2-NSW-197 (Sheet 2 of 3)
Lower Containment Ventilation
Unit 2 Return Line

REV.	DATE	DESCRIPTION	FIELD STATUS
		POUR/ZONE No. 2C7 FLOW DIAGRAM 1-2-5114A	
			Q.S.L. 01
REFER TO ORIGINAL ISSUE MICROFILM FOR SIGNATURES		DWG. No. 2-NSW-197	CONTAINMENT BLDG #2
		SH 2	REV 1
		AEP AMERICAN ELECTRIC POWER	AEP SERVICE CORP. 1 RIVERSIDE PLAZA COLUMBUS, OH 43216

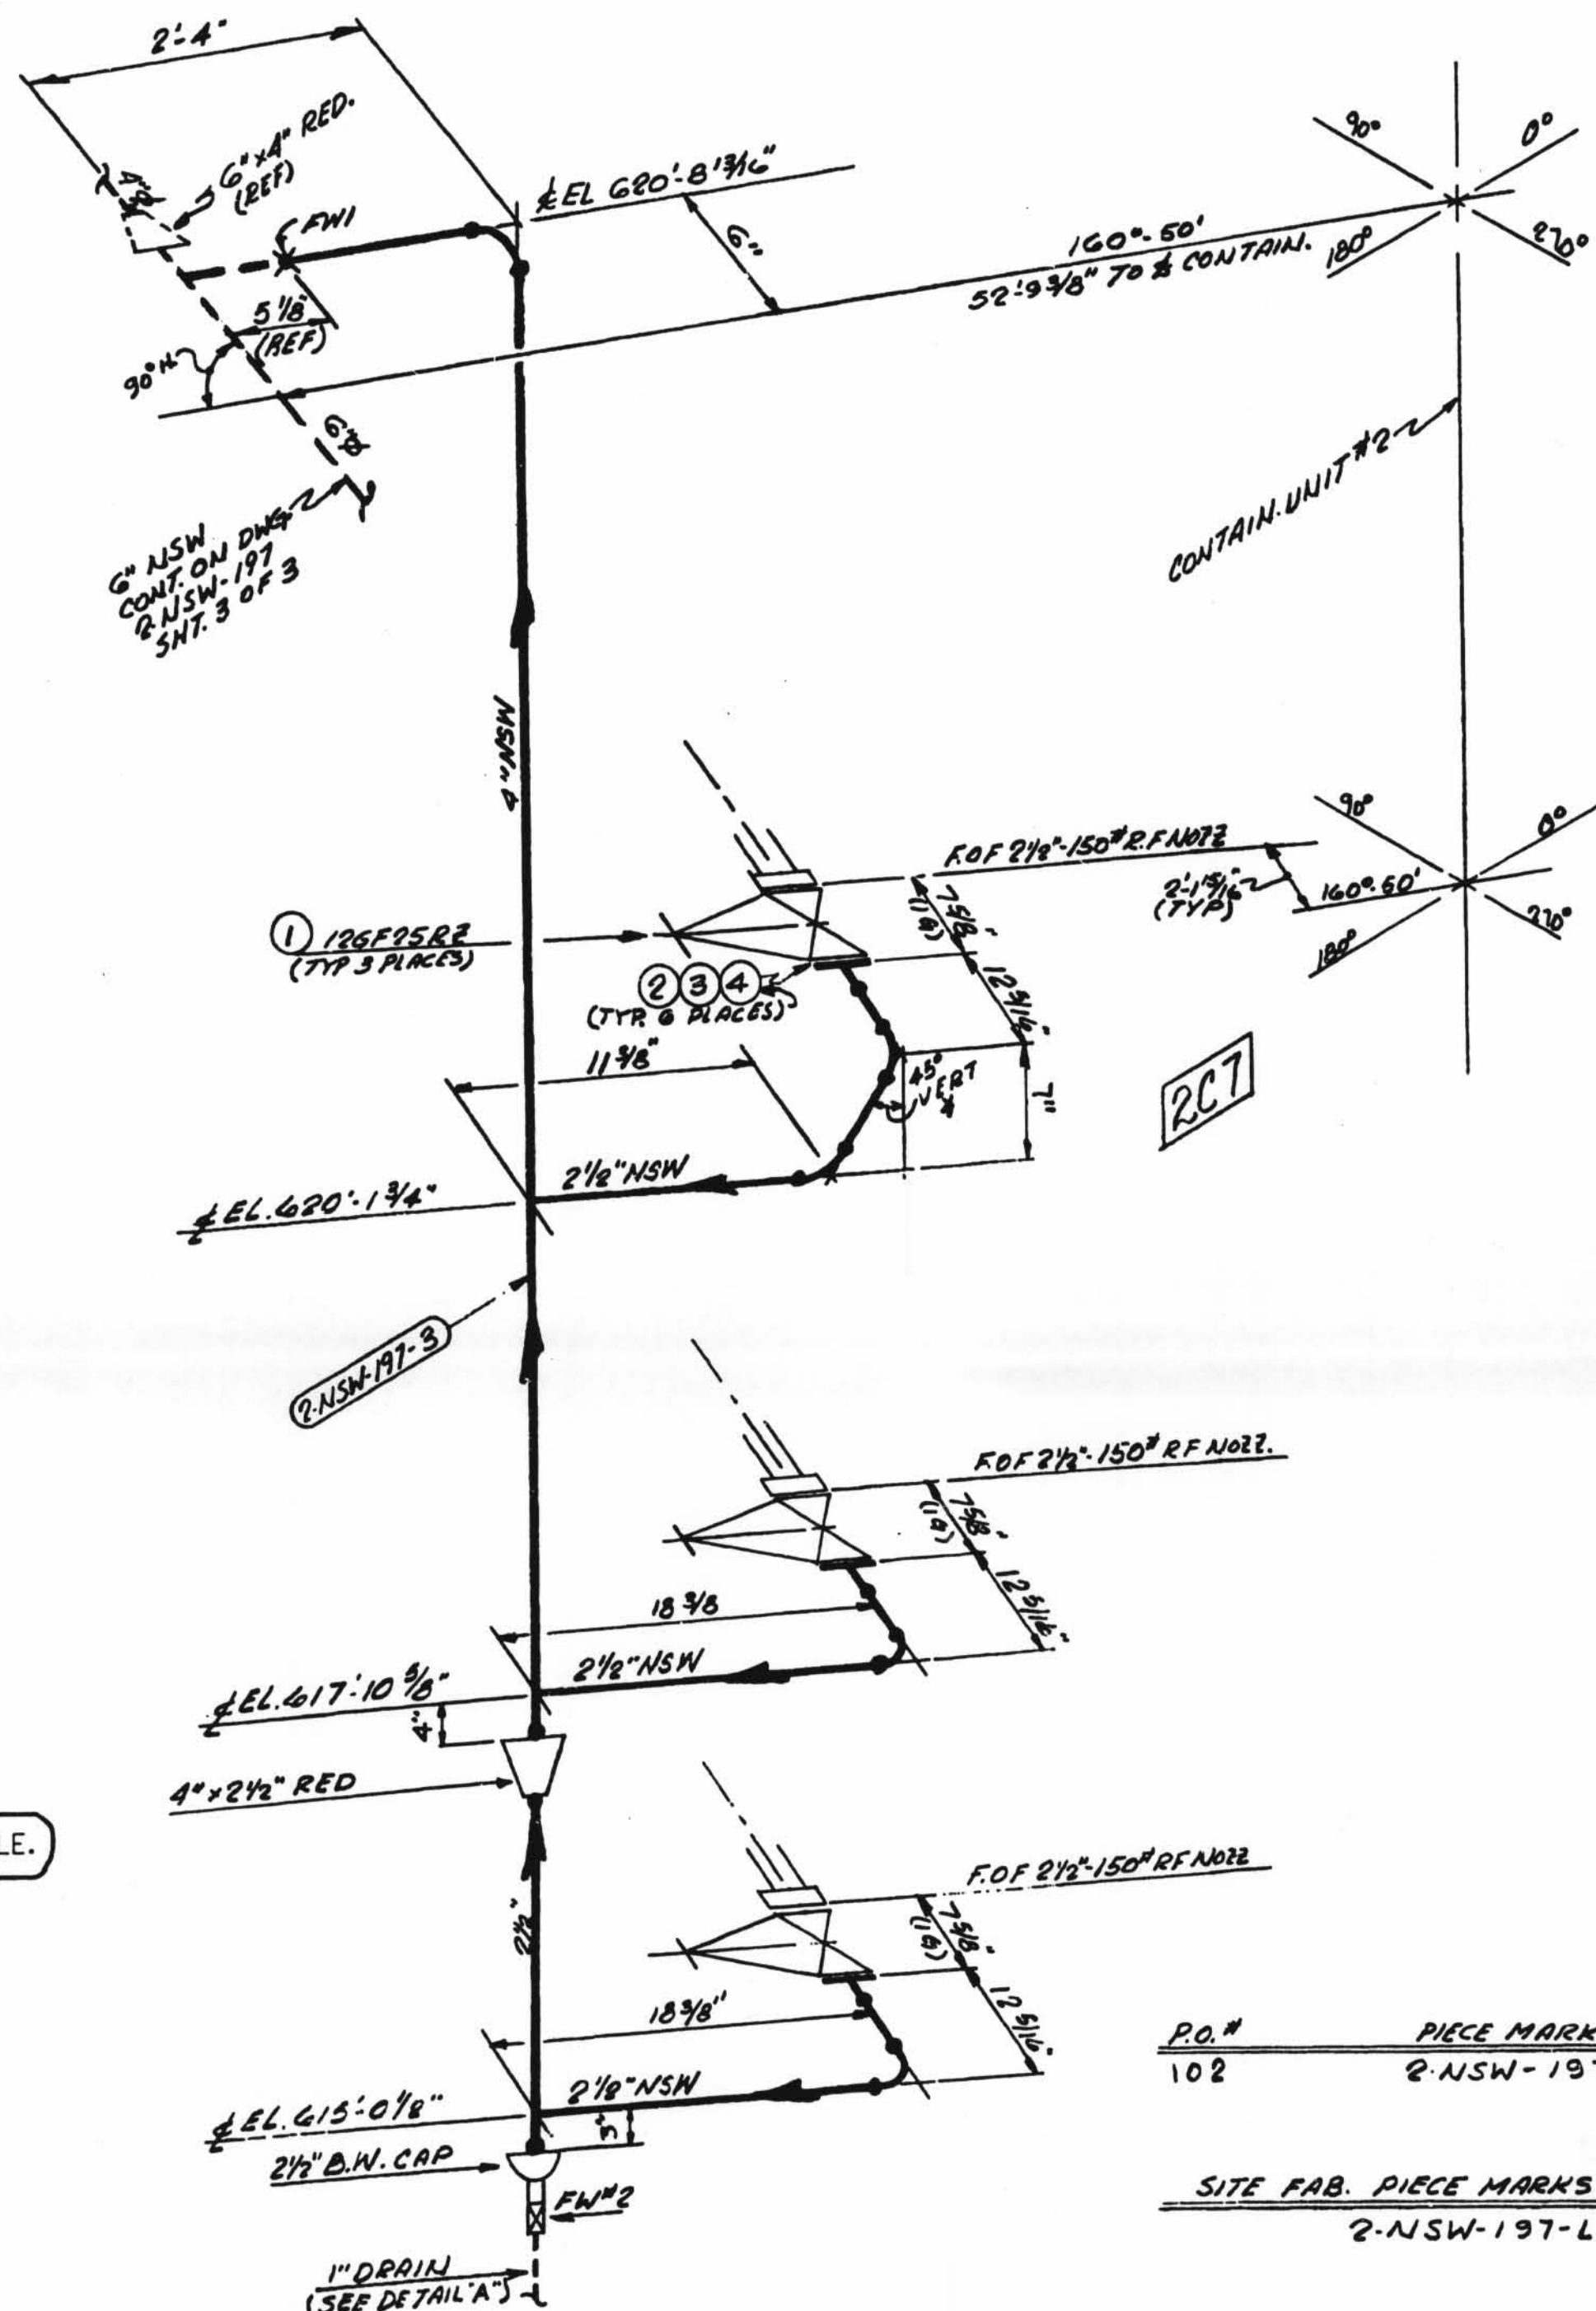
1 09/07/99
THIS DRAWING HAS BEEN CONVERTED FROM A MANUAL FORMAT TO THE IGS-SCANNED DRAWING FORMAT AND SUPERSEDES ALL PREVIOUS REVISIONS.
ADDED: NOTE FOR ITEM 3 PER RFC 12-2769, AB-D02575, DCDR 10-10-1003
GNL/RK/99
NO FIELD ACTION REQ'D.

1. USE CRANE 495 COMPOUND OR GRINNELL 1698 ON ALL THRD. CONNS.
2. USE OF 5/8" φ × 3 1/2" LG. A-307 GR. B BOLT IS ACCEPTABLE.
